KEYSTONE ELECTRONICS CORP.  www.keyelco.com • NEW HYDE PARK NY 11040 • Tel (516)328-7500			
PART NAME			
CERAMIC STANDOFF			
MATERIAL			
GRADE L5 CERAMIC			
FINISH	BOONE DATE 11.22.96		
GLAZED	APP'D RH SCALE 2X		
TOLERANCES INCH [MM] CODE	DWG NO.		
DECIMAL ± .005 [± 0.13 ] ANGULAR ± 1° UNLESS OTHERWISE SPECIFIED	7713

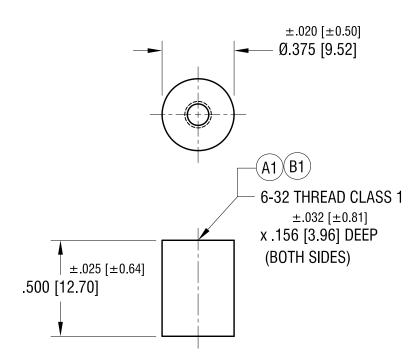
3.30.22	B1 WAS .156±.015 DEEP CHANGE AS PER ECN 22-063	В
10.05.04	ECN 04-130, A1 WAS .187	А
DATE	DESCRIPTION	REV.
